PUR-1751
ADDENDUM NO. 1
INVITATION TO BID

HAGERSTOWN REGIONAL AIRPORT
EXPAND/REHABILITATE TERMINAL BUILDING EAST

DATE: Thursday, June 12, 2025

SHEET No.:
A1.5
40 OF 102

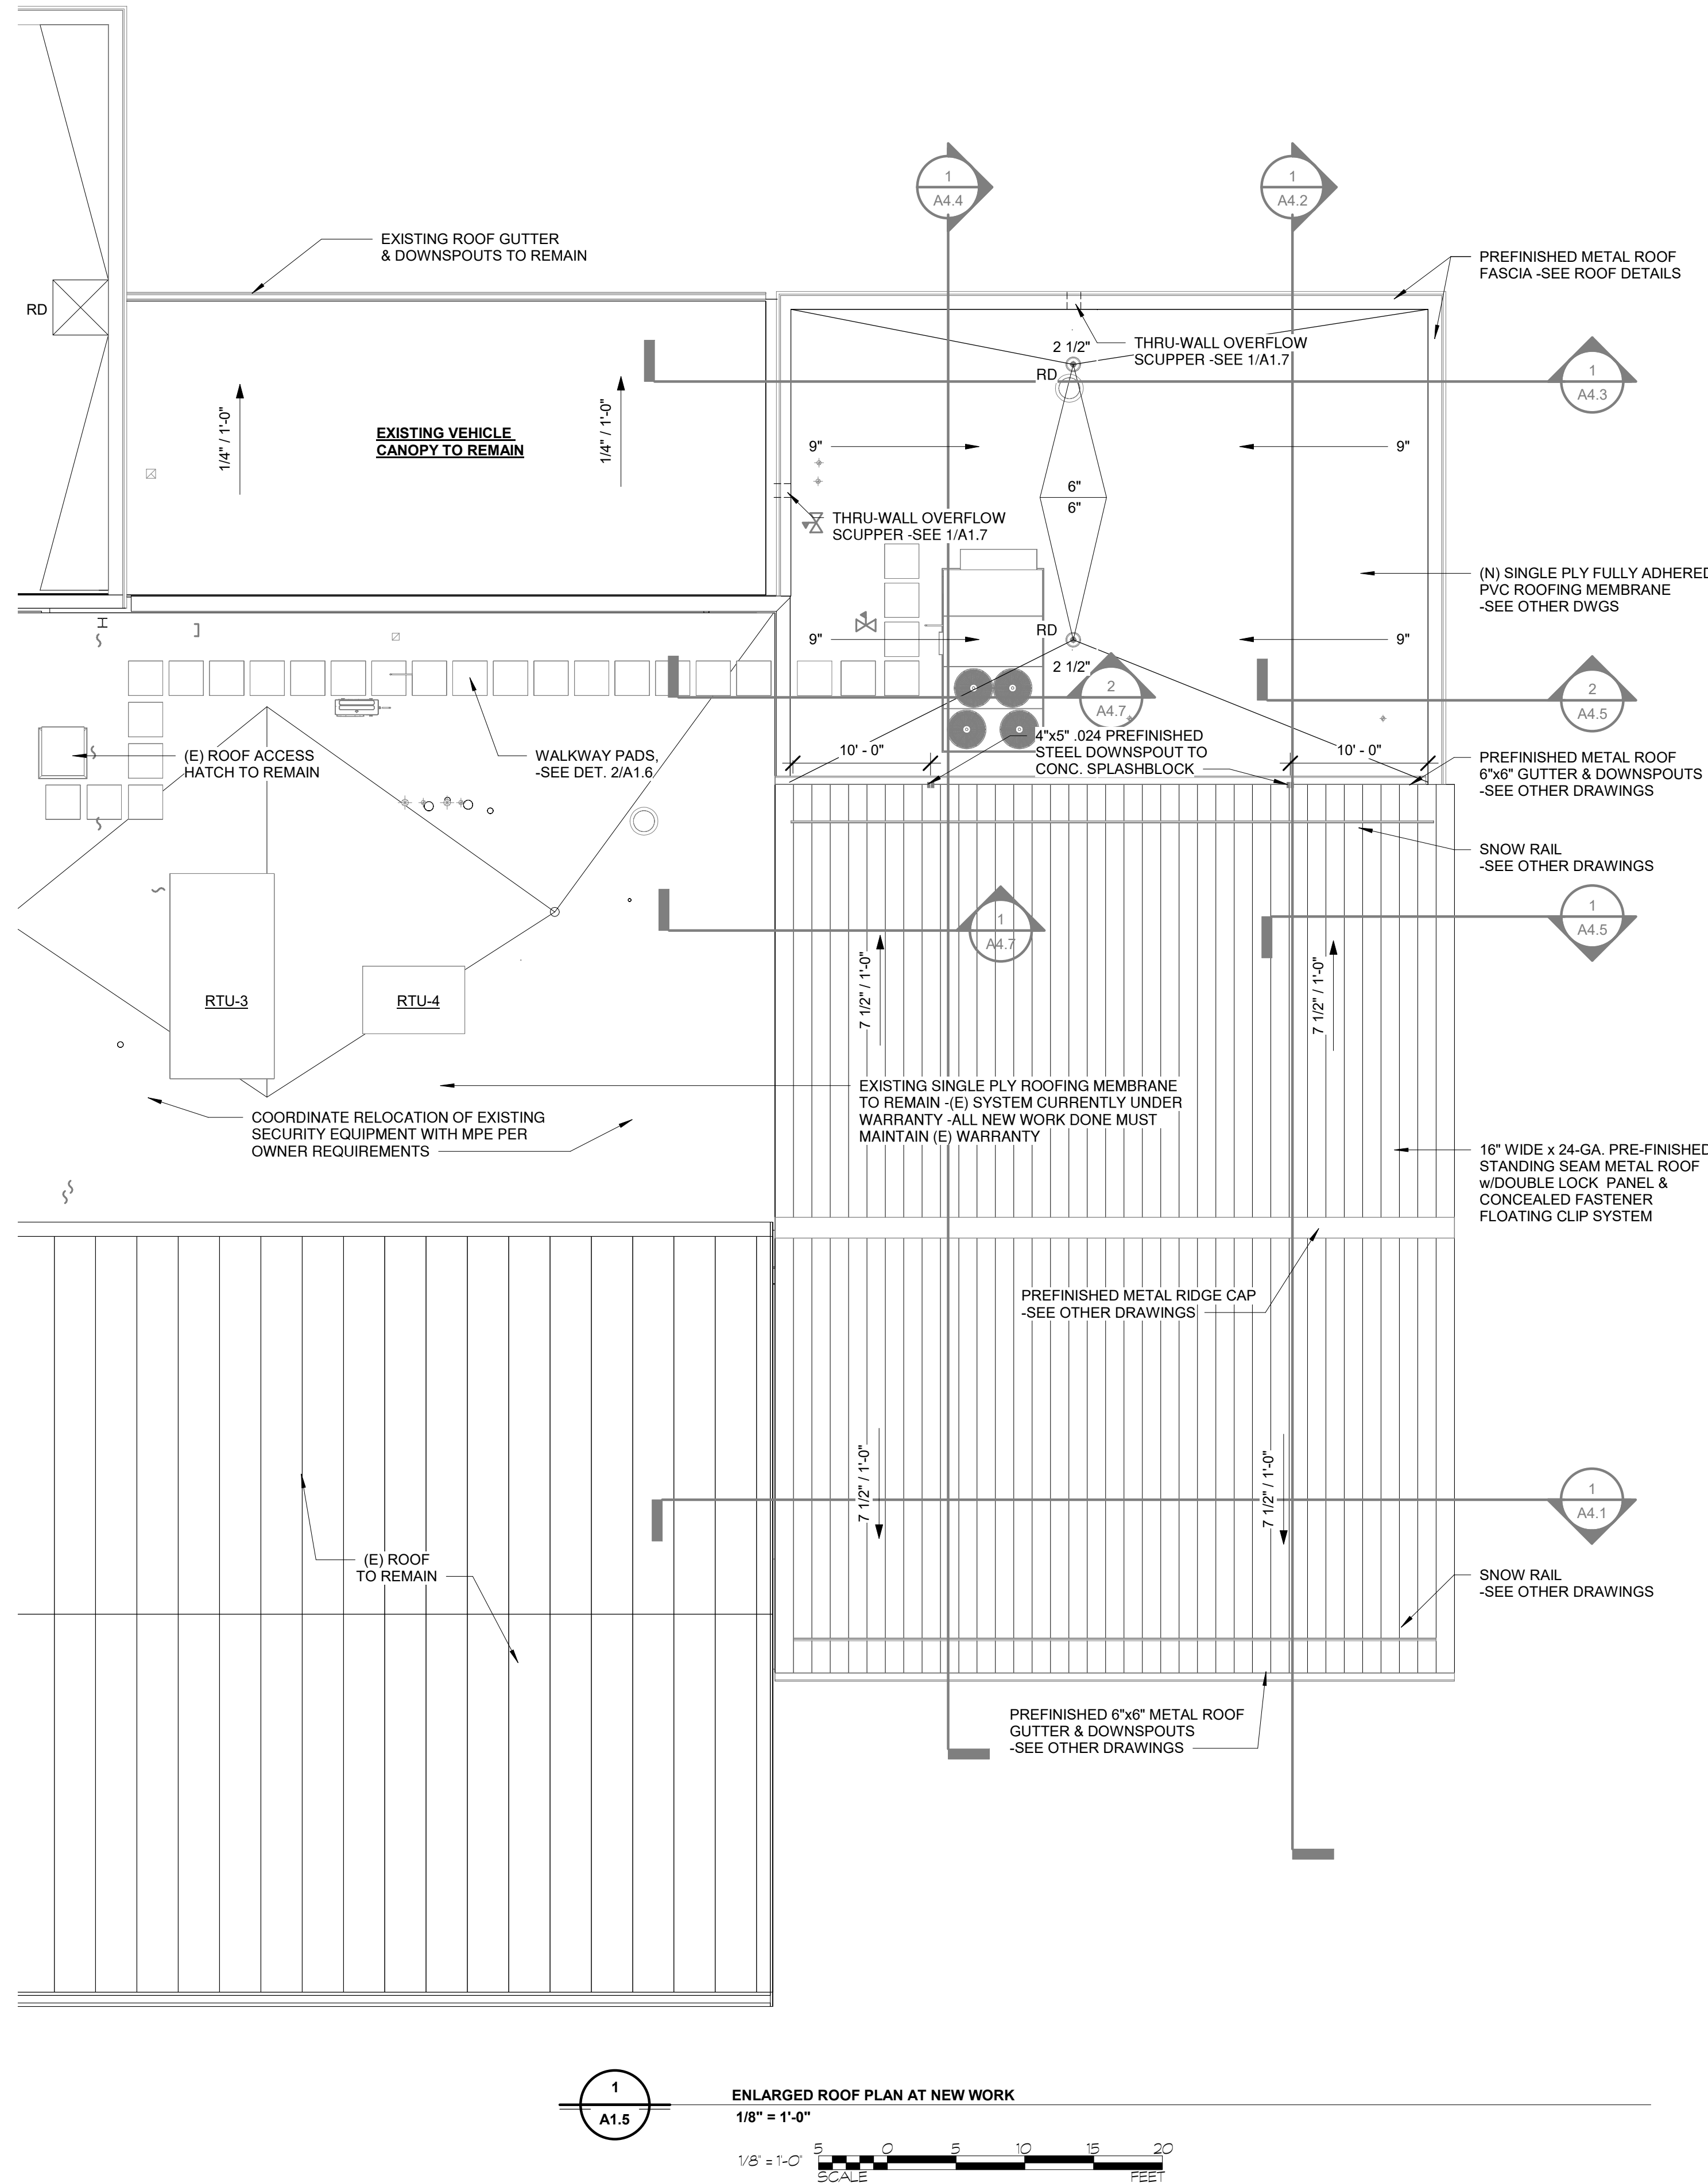
ITEM NO. 12: Inquiry: Section 07-54-19-8, 2.A Walkways. Please provide a layout for the walkways.

Response: DELETE Drawing A1.5 in its entirety and REPLACE with attached REVISED Drawing A1.5, dated 06.10.25. Drawing has been revised to show walkway

pads. (Attachment E)

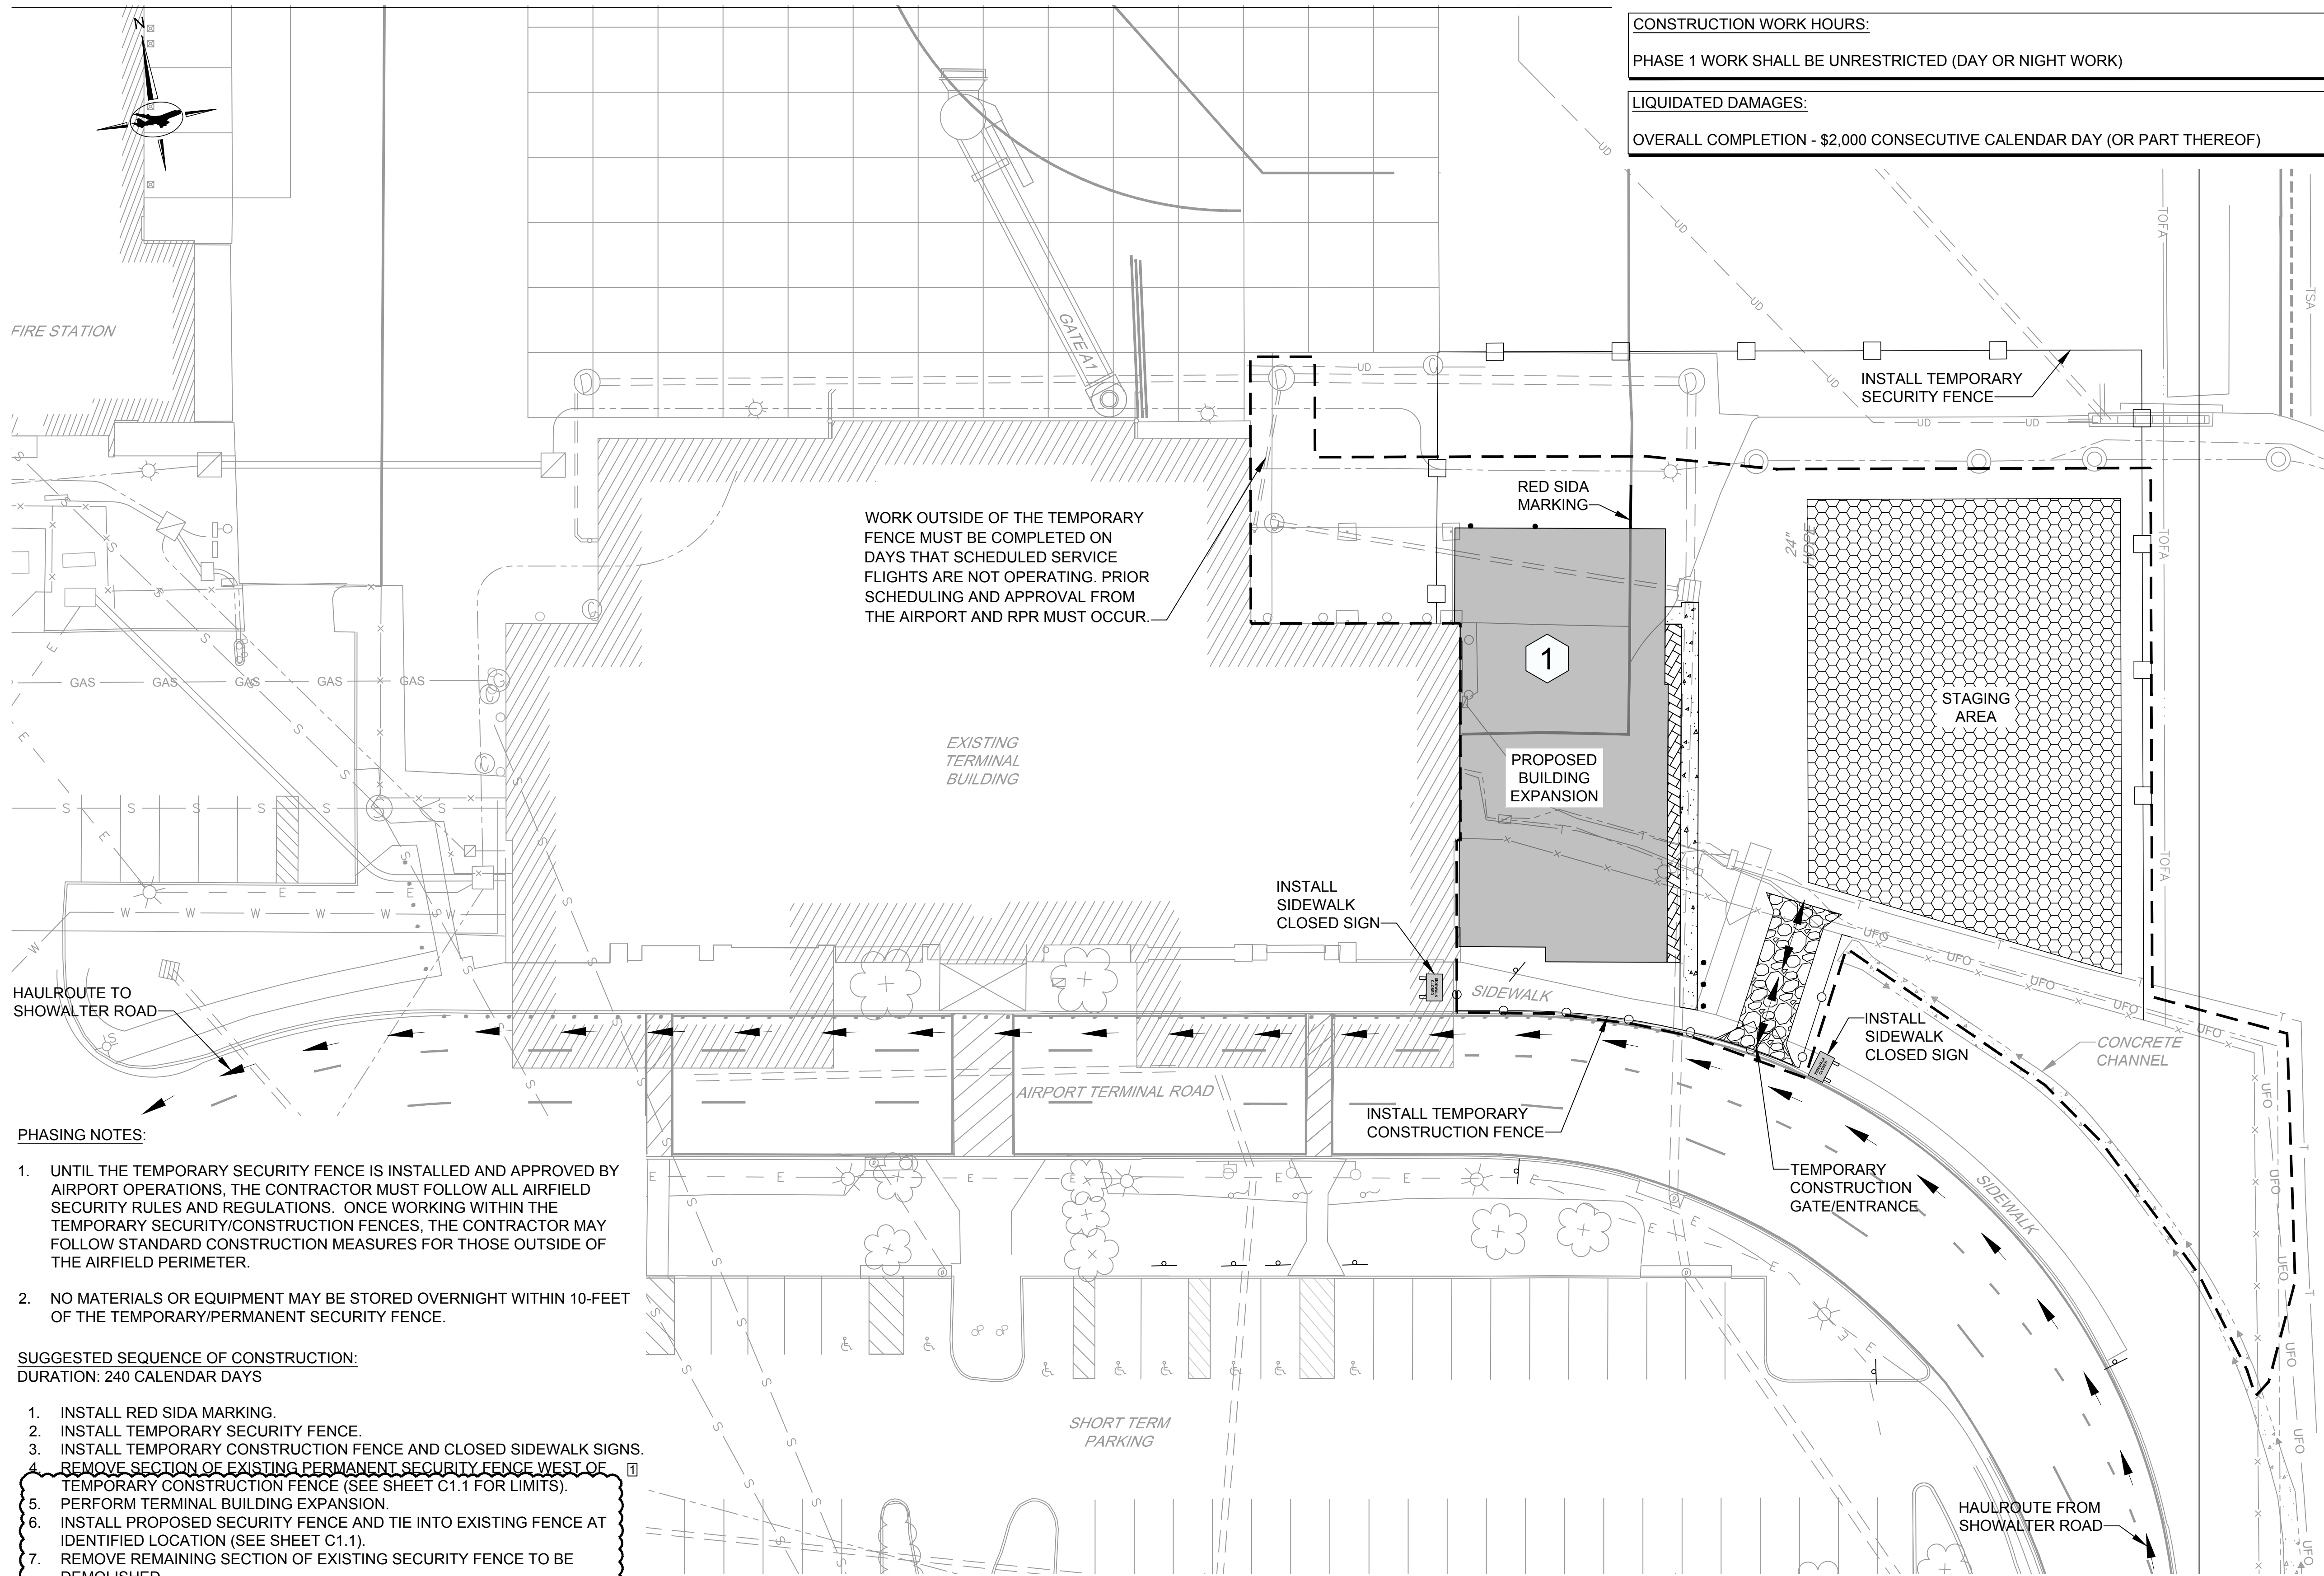
ITEM NO. 5: Inquiry: In Alternate #2 only the additional seats are required, and none of the existing layout is moved to accommodate this layout?

Response: DELETE Drawing A1.9 in its entirety and REPLACE with attached REVISED Drawing A1.9, dated 06.10.25. Drawing has been revised to show new seating throughout. (Attachment E)

SHEET No.: G2.0

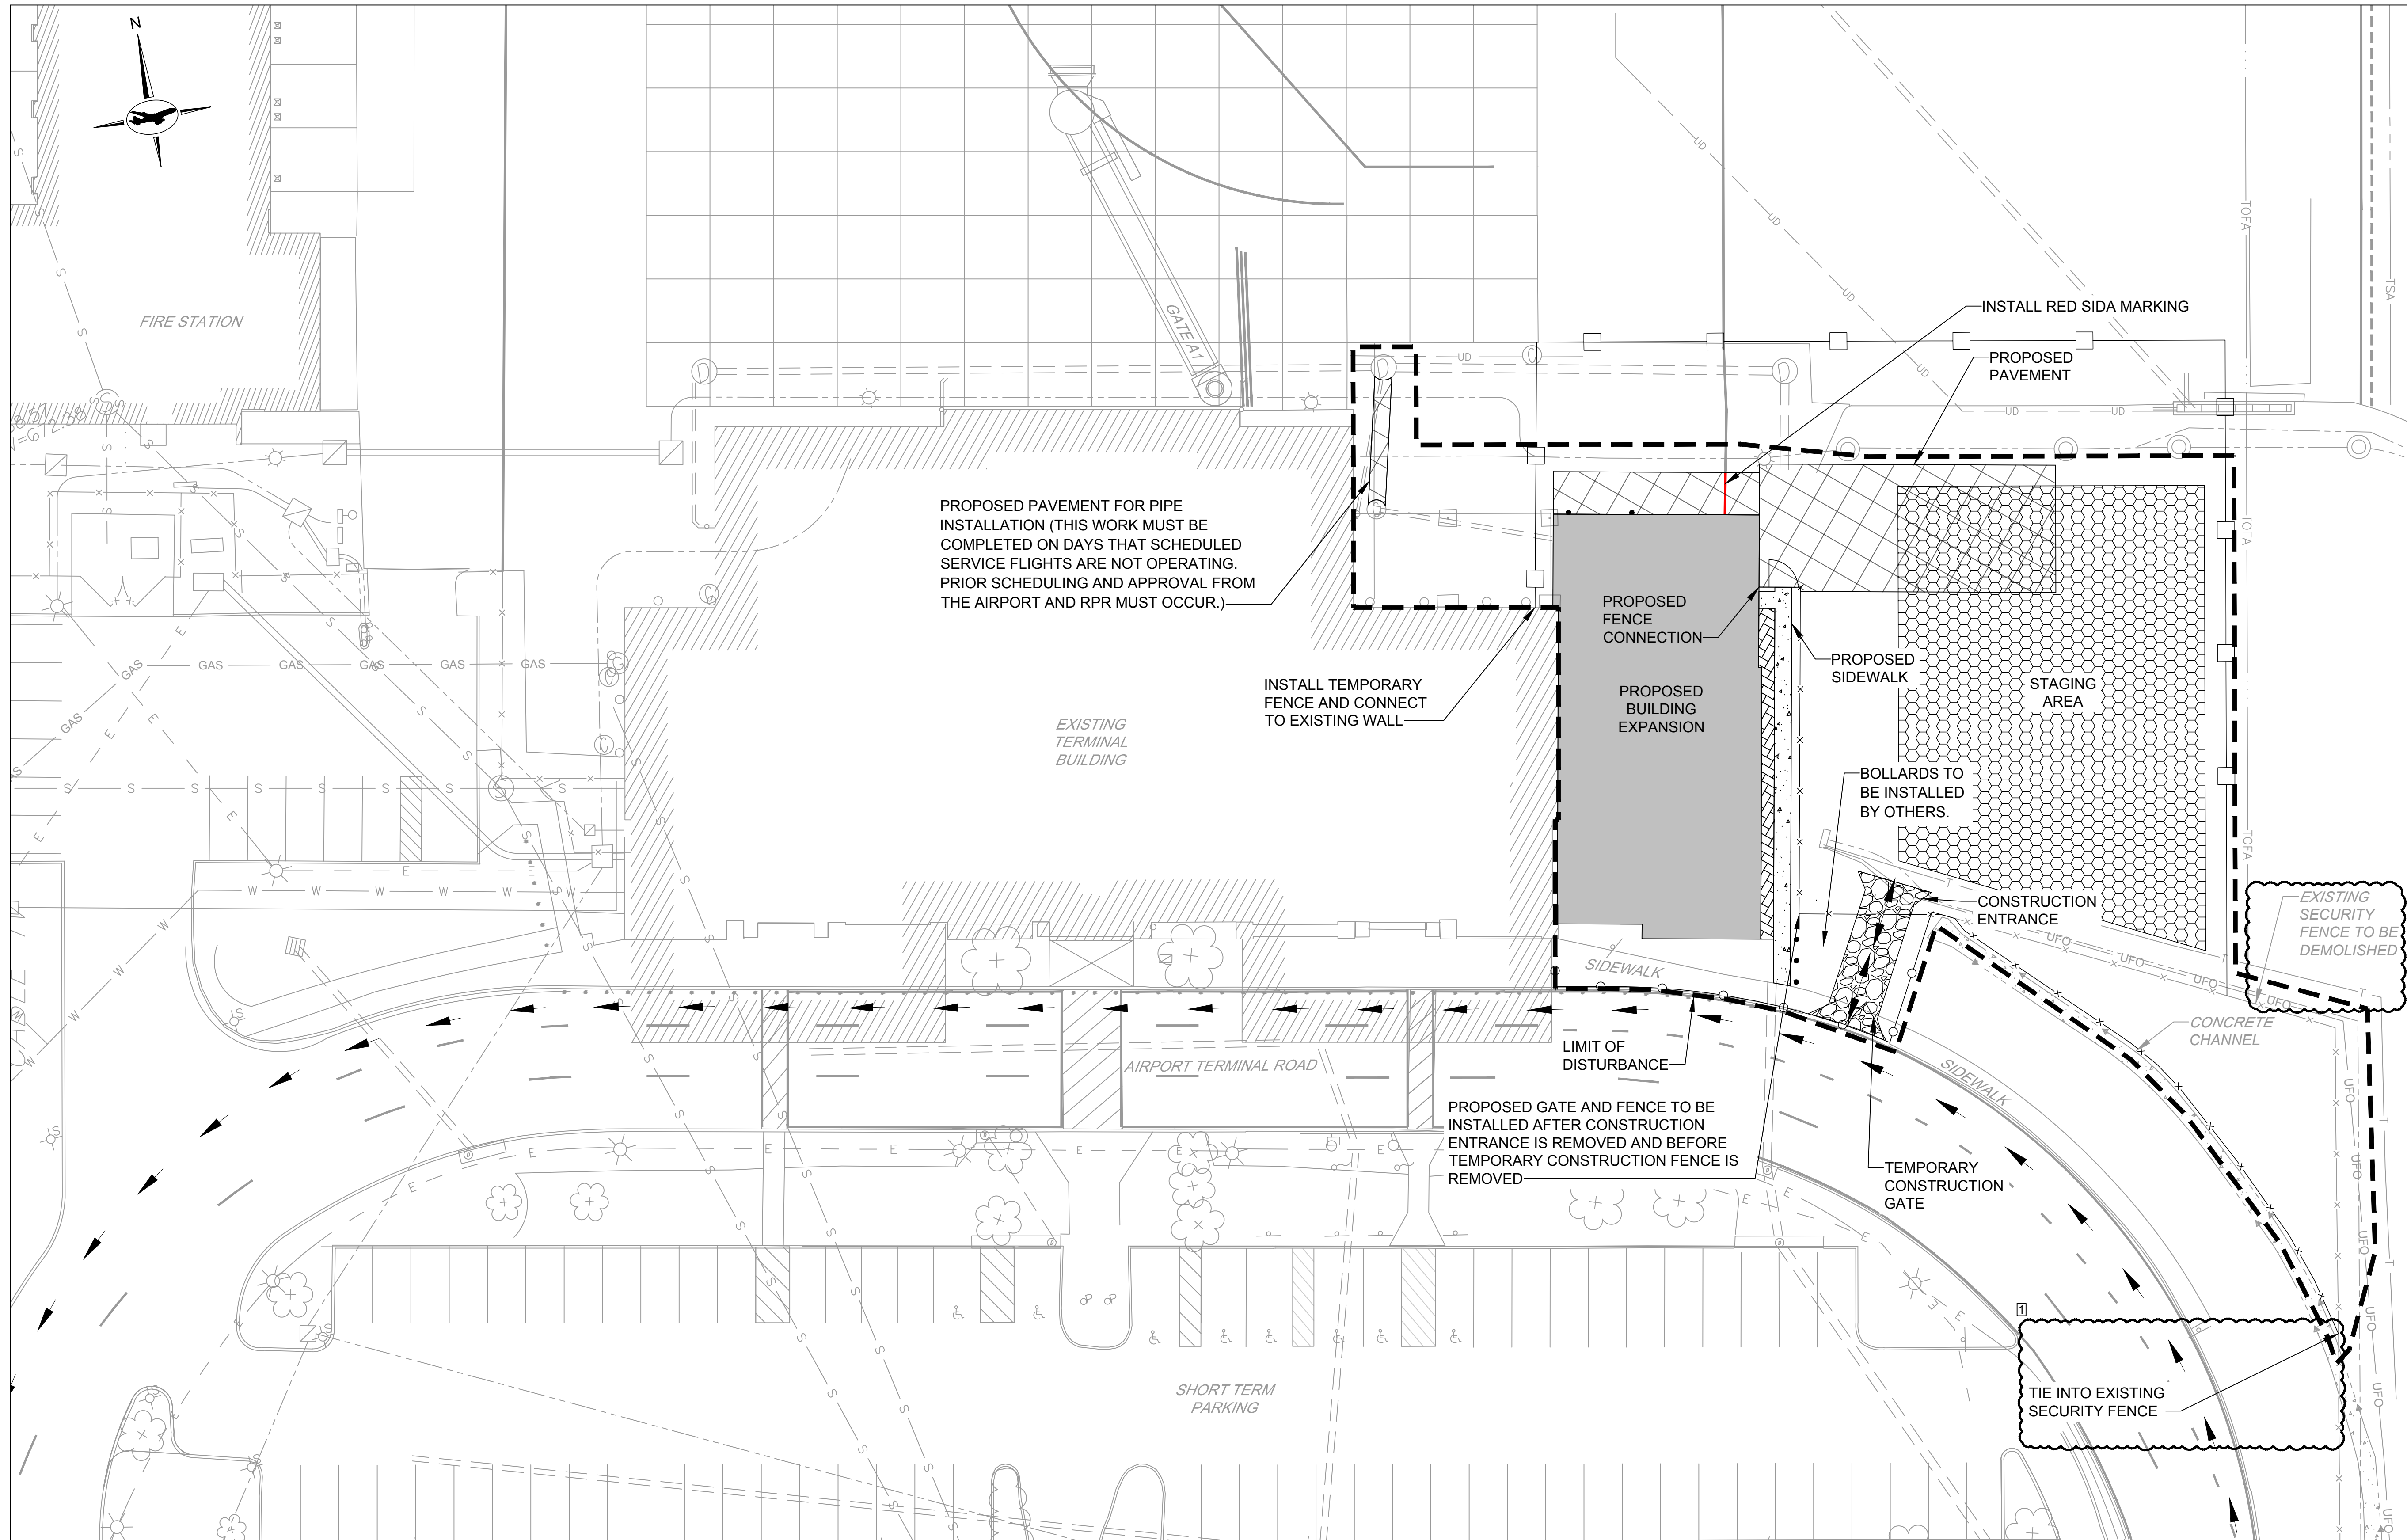
ITEM NO. 16: Sheet No. G2.0 Construction Safety and Phasing Plan:

REVISE: Suggested Sequence of Construction to specify security fence phasing.
